M5 Junction 10 Improvements Scheme

Change Application 2 Environmental Statement Addendum TR010063 – APP 10.23

DCO Change Application Environmental Statement Addendum

Regulation Number:	Regulation 5 (2) (a)
Planning Inspectorate Scheme Reference	TR010063
Application Document Reference	TR010063/APP/10.23
Author:	M5 Junction 10 Improvements Scheme Project Team

Figure 10-2 The locations of the changes

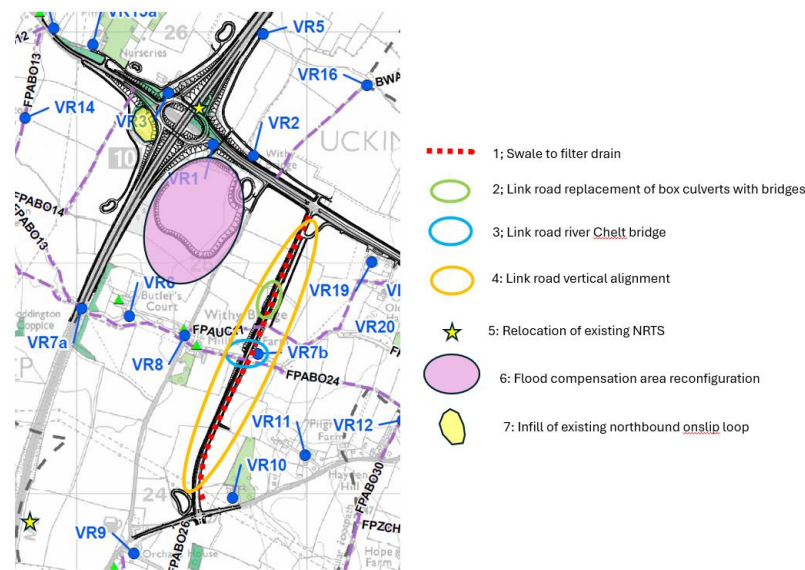
- 10.2.3. The potential visual impacts are distinct to each change. The construction stage visual impacts will be the same with or without the changes, as similar construction activities to those assessed in the ES are required for each change.

- 10.2.4. The operational visual impacts for each change have been considered in turn.
